SYDNEY METRO PITT STREET SOUTH OVER STATION DEVELOPMENT

Response to Submissions (SSD
10376 & SSD 8876-2)

Figure 2 Level 06 Outdoor – Proposed in-accessible courtyard landscape design

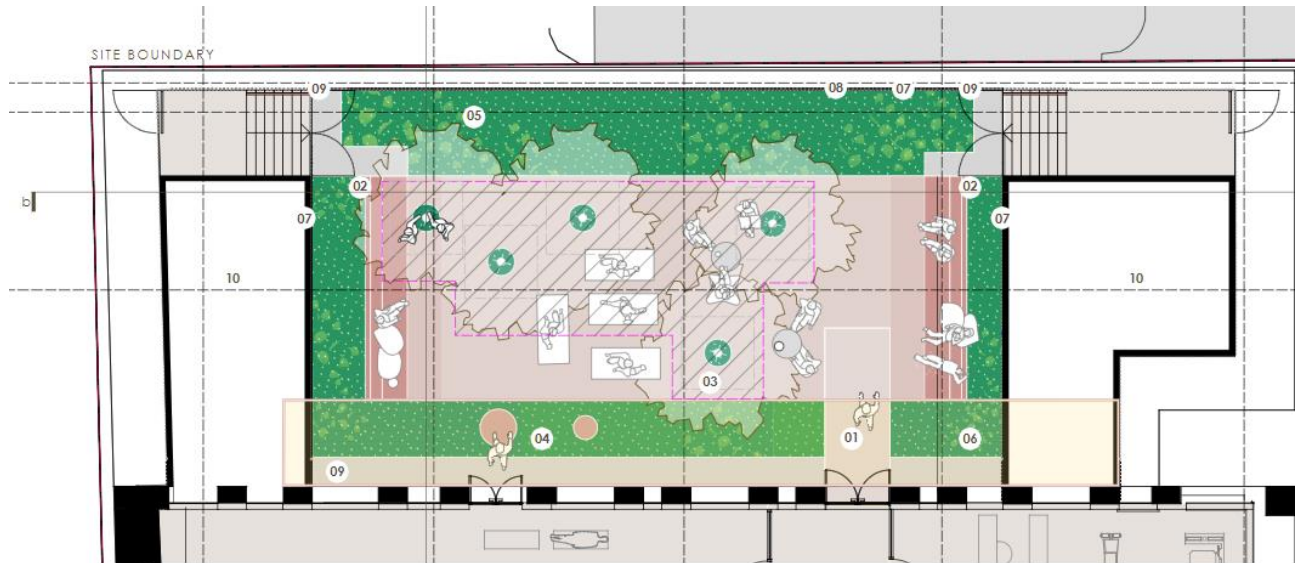
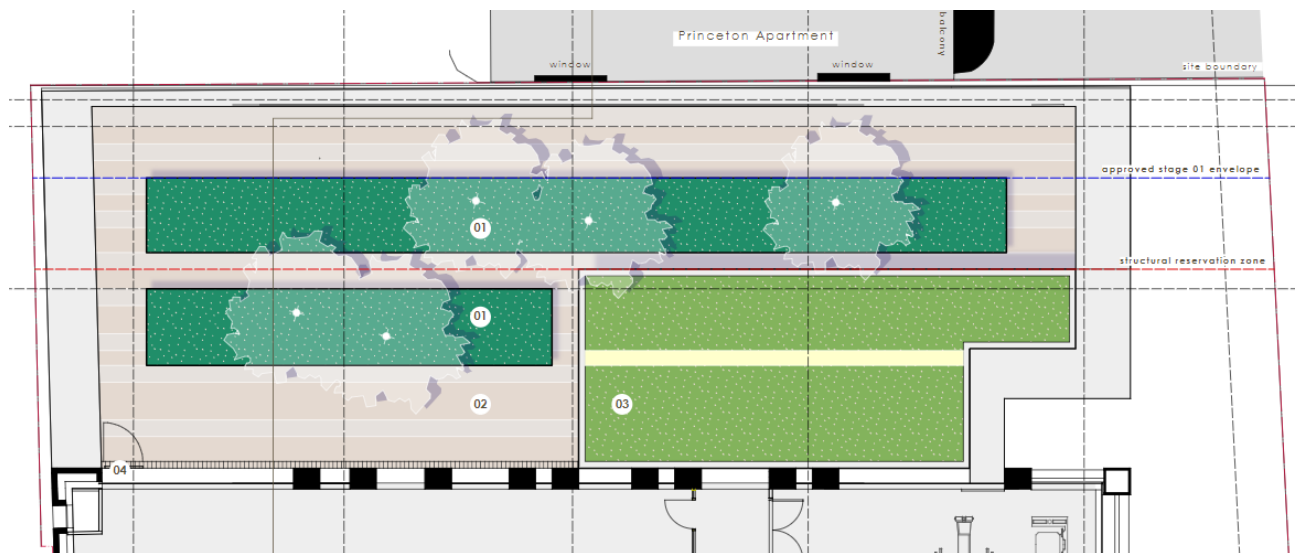
In response to concerns about privacy impacts over Princeton Apartments arising from the Level 06 communal open space this area has been amended to a in-accessible landscaped space. While this area did contribute to valuable communal open space to the development it is acknowledged that the amenity of the space was compromised by low levels of solar access and proximity to habitable windows in the Princeton Apartments' northern facade.

To address submissions raised by the Princeton Apartment residents, the Level 06 courtyard has been re-purposed and redesigned as an in-accessible landscaped space. The space will provide a green breathing space between the Princeton Apartments and the OSD tower providing visual relief within the city and a pleasant outlook for residents both of the proposed development and of Princeton Apartments.

Planting will be located in raised elongated planter beds with light planting on top of the relocated plant room to the west of the courtyard. Plant species selection includes shade-tolerant perennials as a ground cover for the planter beds and above the plant room, as well as a copse of Water Gum providing visual screening between the two buildings. The plant room, at 1.5m high, will create a visual barrier between the internal wellbeing space and the Princeton Apartments northern windows.

The planter beds maximise the extent of landscaping within this space whilst also providing clear paths for maintenance access as required. It is noted all built form has been removed from the structural reservation zone identified within concept approval.

Figure 4 Original and Revised South East Apartment Layout

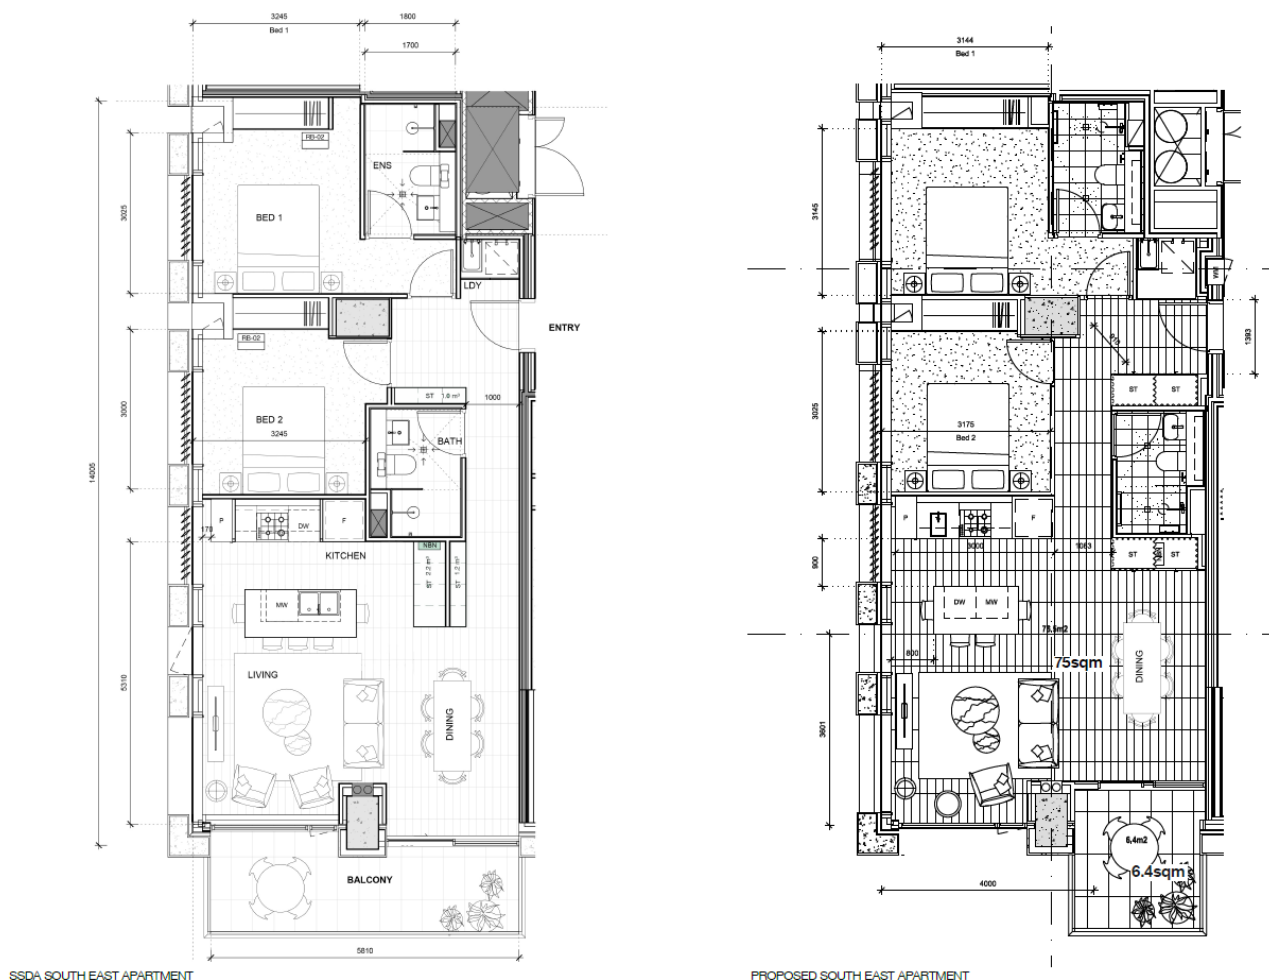
In order to maintain the minimum internal area for this apartment type and remove overlooking opportunities from the balcony to Princeton Apartments, the balcony area itself falls slightly below the ADG minimum at 6.4m² (rather than 10 m²). It is noted that the regular size and layout of the balcony ensures it remains useable by multiple residents as illustrated at Section 3 of the Bates Smart Architectural Design Report at **Appendix B**.

The Design Review Panel has supported this approach to maintaining internal area compliance whilst reducing the balcony area below the ADG minimum to balance internal apartment amenity with privacy protection to Princeton Apartments as outlined within the DRP Meeting minutes at **Appendix J**.

Figure 6 Level 35 Balustrade revised location below Sun Access Plane

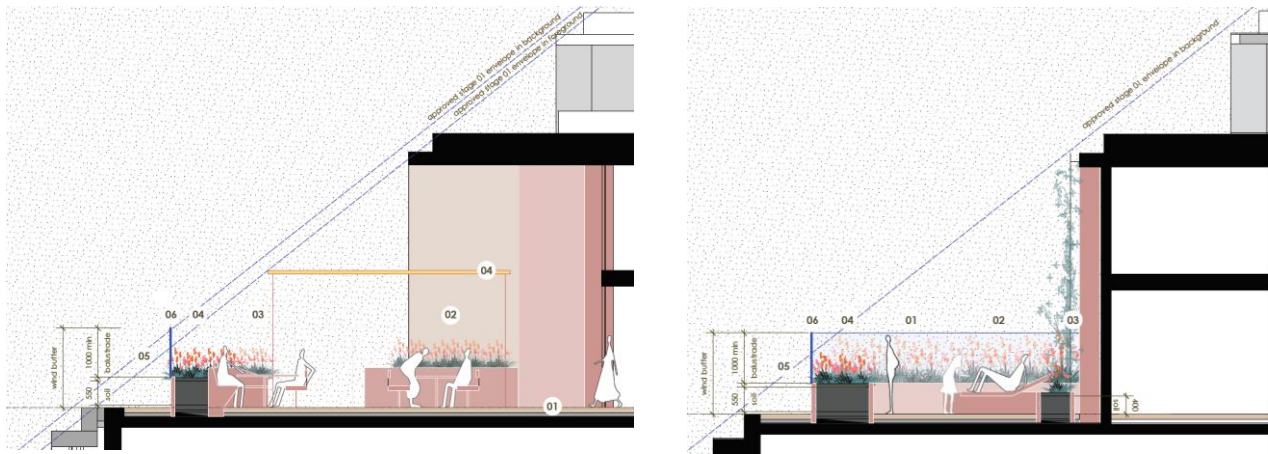
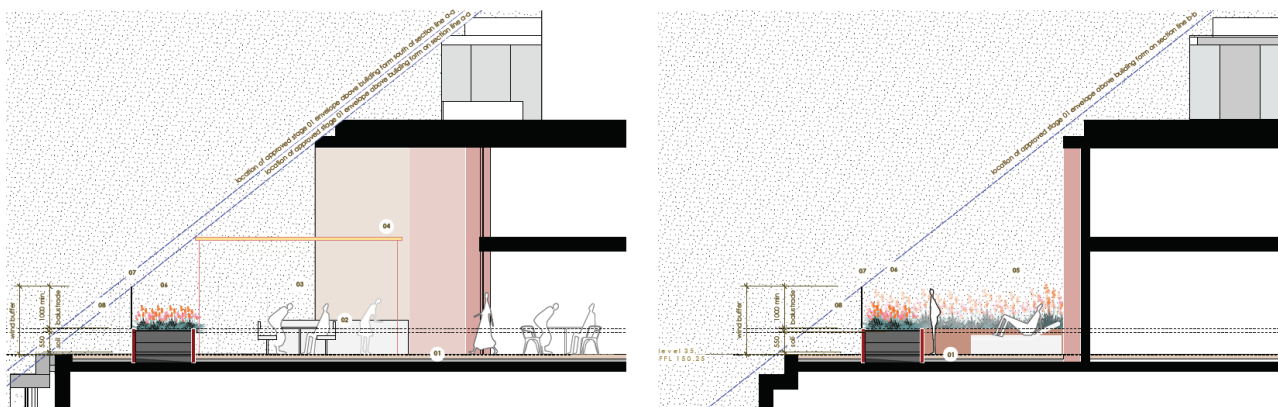
The design lodged on 19 May 2020 proposed glass balustrades on the outer edge of the planter boxes surrounding the Level 35 communal open space terrace. These balustrades projected above the building envelope which is also the Hyde Park Sun Access Plane.

To ensure compliance with the concept building envelope and sun access plane, the eastern edge of the planter boxes have been pulled in westward so that the balustrade sits up to but not beyond the building envelope and sun access plane.

To ensure adequate planter bed width, the inner edge of part of the planter bed to the southern portion of the terrace has also shifted westward resulting in a minor reduction in the area of accessible open space at Level 35 by 11 m² from 237 m² to 226 m².

Figure 7 Reduced GRC Extrusion to Western Envelope

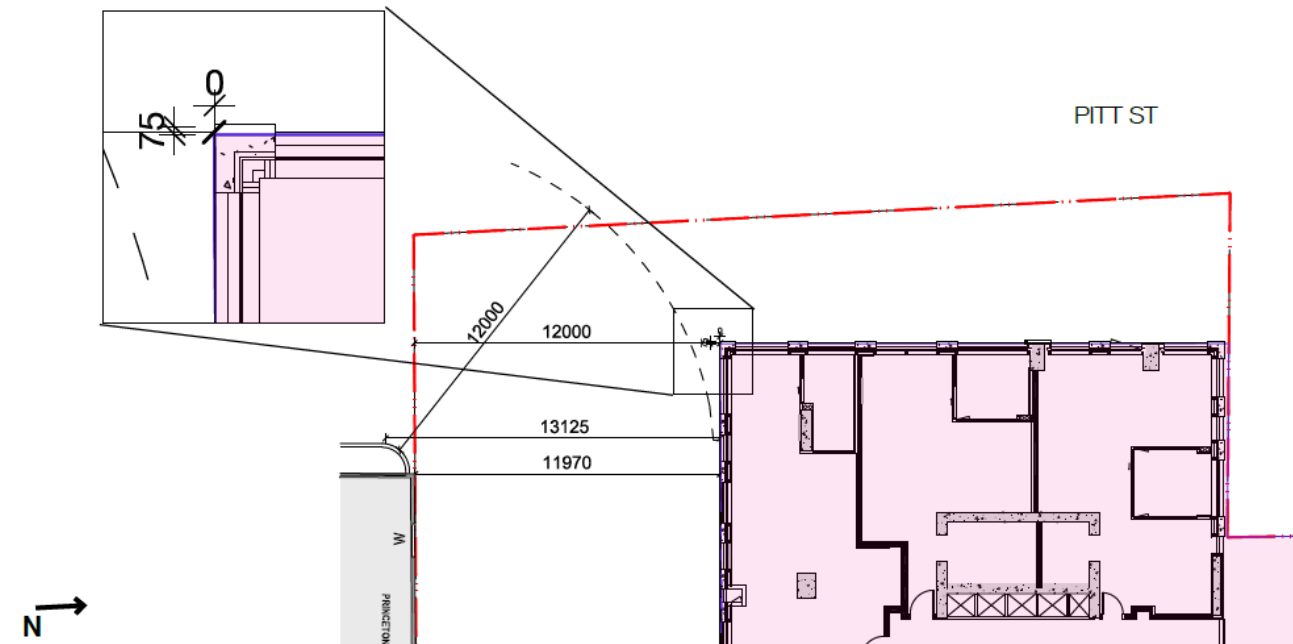
Demonstrate compliance with Condition B3 of the Concept Approval, and provide detailed illustrations showing how the proposed built form satisfies the following subclauses:

The resultant projections beyond the approved concept envelope are:

- 75mm to the western façade, and
- 0mm to the southern envelope extent at the south western corner of the building (which is the most influential point for solar impact to Princeton Apartments) as shown in Figure 7.

Figure 8 Option Testing for South Western Apartment Setback

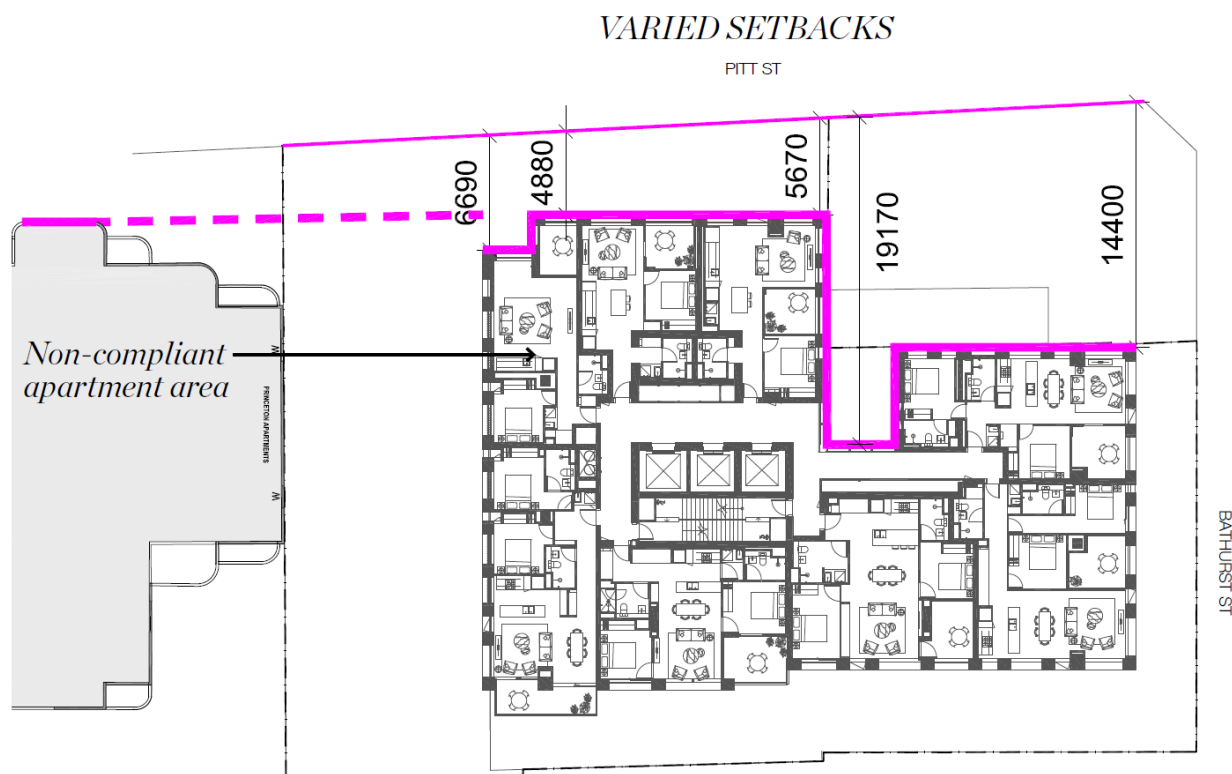
A sensitivity analysis was undertaken to assess the solar impacts to both the proposed development and Princeton Apartments of a setback variation to the south western apartment. This explored setting back the corner of the south western apartment by an additional 2m (approx.) inside the approved concept envelope, at the point where the proposed development begins to cast shadow on the adjacent development. Refer Figure 8.

This demonstrates that whilst an increased setback offers some minor benefit to solar access to Princeton Apartments it results in a significant amenity reduction to 30 apartments within the proposed development by way of solar non-compliance or area non-compliance which is a more significant loss in amenity than that which would otherwise be gained by Princeton Apartments.

Figure 9 Revised Pitt Street Setback

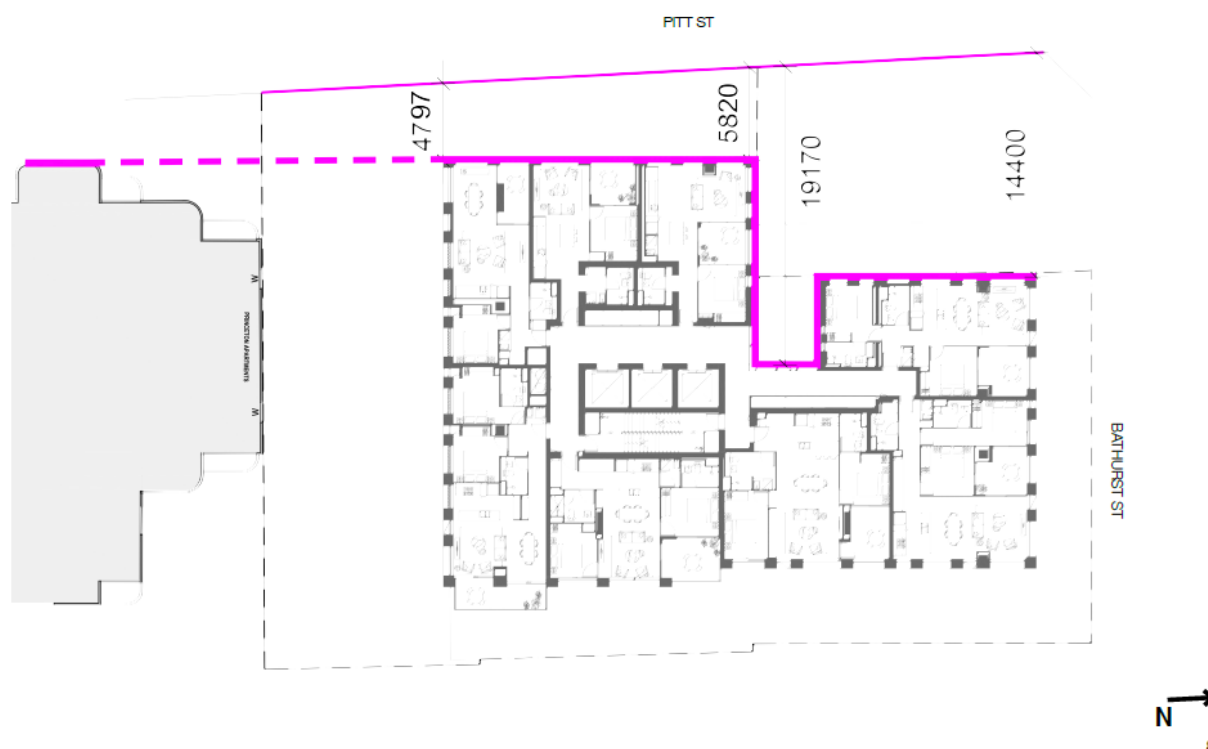
The resultant design retains a varied setback to Pitt Street, ranging in distance from 4.78m to 5.82m, south of the Edinburgh Castle Hotel as shown in the extract at Figure 9.

- The reduction in the façade articulation depth now means that all 9 units that lost 3 minutes of solar access have no reduction in solar access.
- The overall modification to the proposed development results in an approved solar access of 263 minutes to Princeton Apartments compared to the approved concept envelope (an increase of 42 minutes compared to the originally submitted scheme).

Figure 12 Projections beyond building envelope (southern elevation)

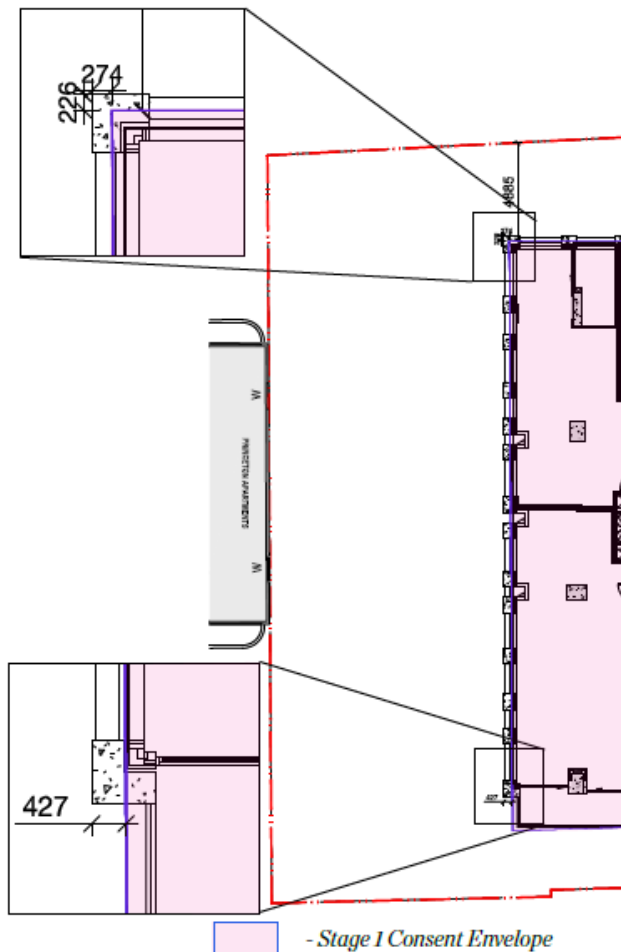
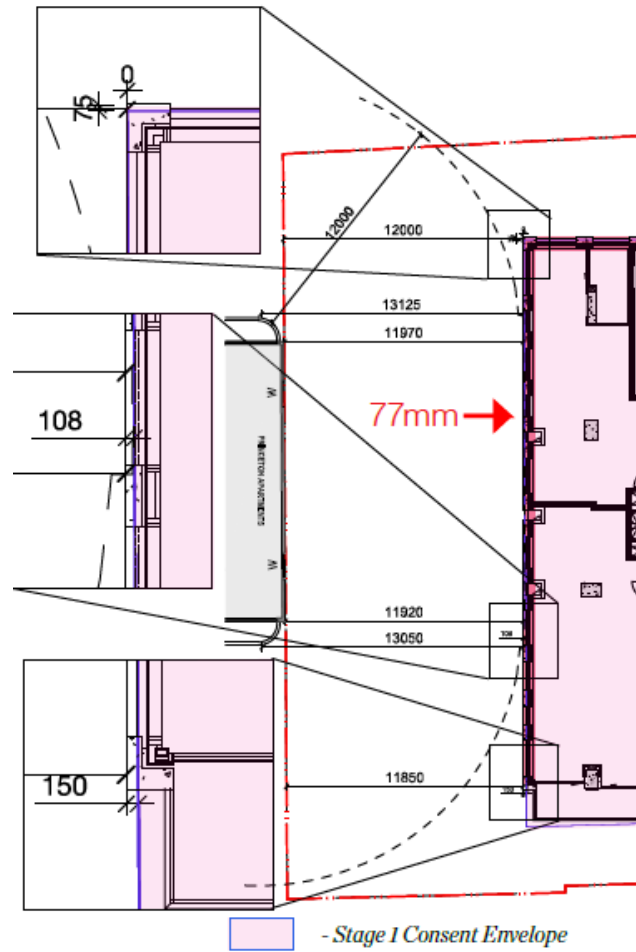
In order to bring the building as far as possible within the approved concept envelope and minimise the extent of projections beyond the envelope, Bates Smart has explored a number of strategies. The initial response was to investigate reducing the depth of the GRC from 400mm (with a 50mm gap to the facade) to 250mm (with no gap to the facade) to bring the building within the envelope whilst reducing shading to the facade and maintaining design integrity.

- 75mm to the Pitt Street envelope
- 325mm to the Bathurst Street envelope
- Between 0mm and 150mm to the southern envelope fronting Princeton Apartments. The varied protrusion extent to the southern is a result of that envelope alignment being slightly off 90degrees from the western envelope alignment, whilst the building is designed at 90 degrees from the south western corner. It is noted that:
 - The maximum incursion into the 12m setback arc between the northern facade of Princeton Apartments (on the boundary) and the proposed building facade is 108mm. This occurs at the eastern most interface of the Princeton Apartment's north facade. This non-compliance reduces to 0mm at the western most interface of the Princeton Apartment's north facade.

Figure 12 compares the extent of the projections beyond the building envelope from the application as lodged with the amended design.

Figure 14 South facing louvres in relation to Princeton Apartments

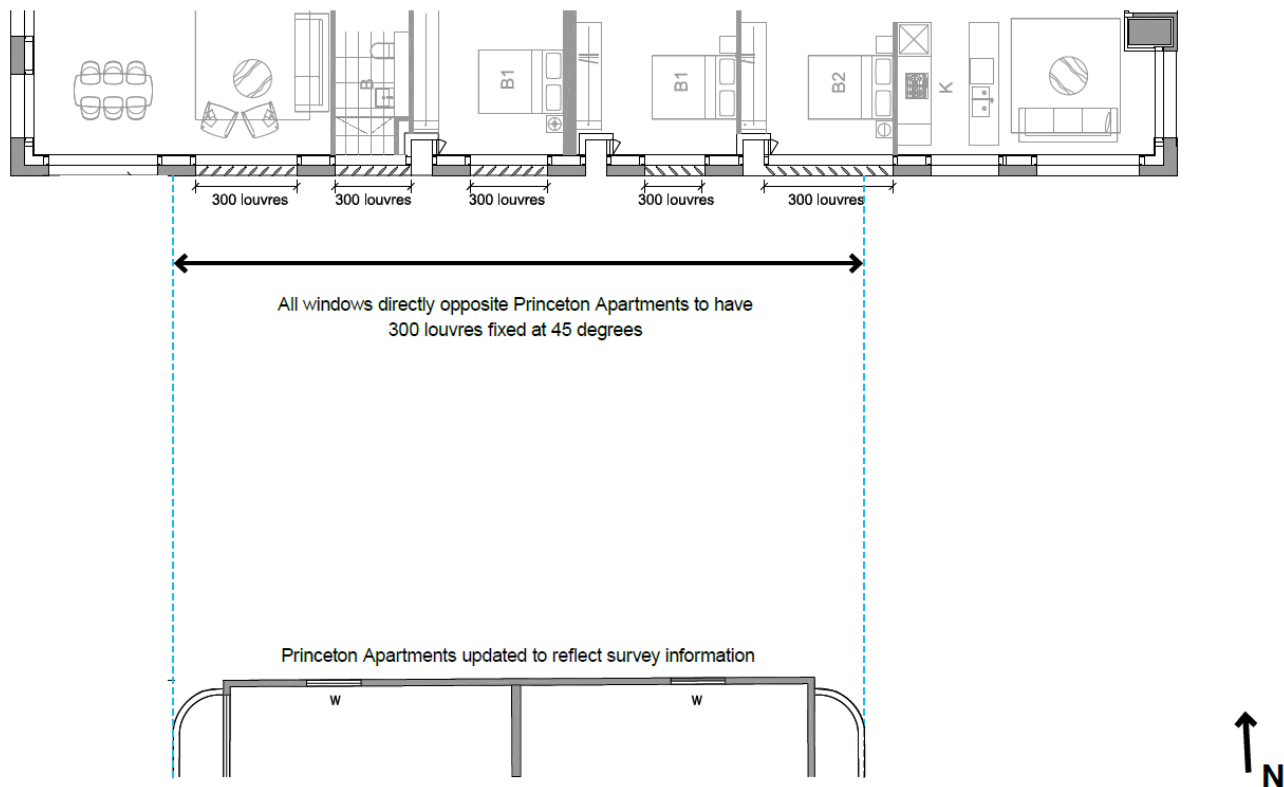
The planting proposed on the outdoor area at Level 06 courtyard will provide increased landscape screening and a privacy buffer between the windows of the Princeton Apartments windows and the internal amenity space.

The balcony to the south-east apartment has been moved north along the façade and inboarded within that apartment to remove the opportunity for overlooking between the balcony and Princeton Apartments.

Louvres to the proposed habitable rooms of the south facing apartments are retained where they interface with the north facing Princeton Apartment windows. Refer louvre diagrams within the supplementary Architectural Design Report and extract below showing the interface between the two buildings.
